Heart of America Northwest

Proposed Extension of Apatite Barrier to prevent Strontium-90 from reaching the Columbia River

Strontium-90 contamination plume in 100-N groundwater; the federal Drinking Water Standard is 8 pCi/L, and the area shaded red is over 1,000 times the Drinking Water Standard. Image from 2008 Hanford Site Groundwater Monitoring Report

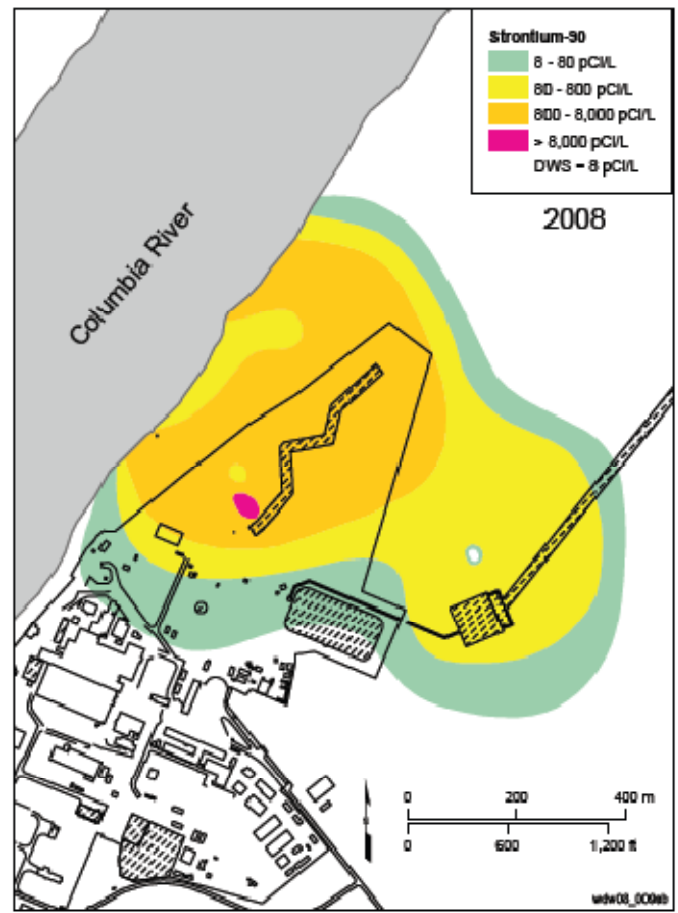
- We are concerned that USDOE plans to only construct the apatite barrier to a depth of approximately 30 feet, when non-USDOE models indicate that the majority of the Strontium-90 is in the lower part of the aquifer;

- Another factor of our concern is that permeability of the barrier will decrease over time. As the barrier plugs up with Strontium-90 or some other media, groundwater will simply flow around the barrier. If the barrier does not extend all the way to the bottom of the aquifer, contaminated groundwater could flow under the barrier and proceed into the Columbia River;
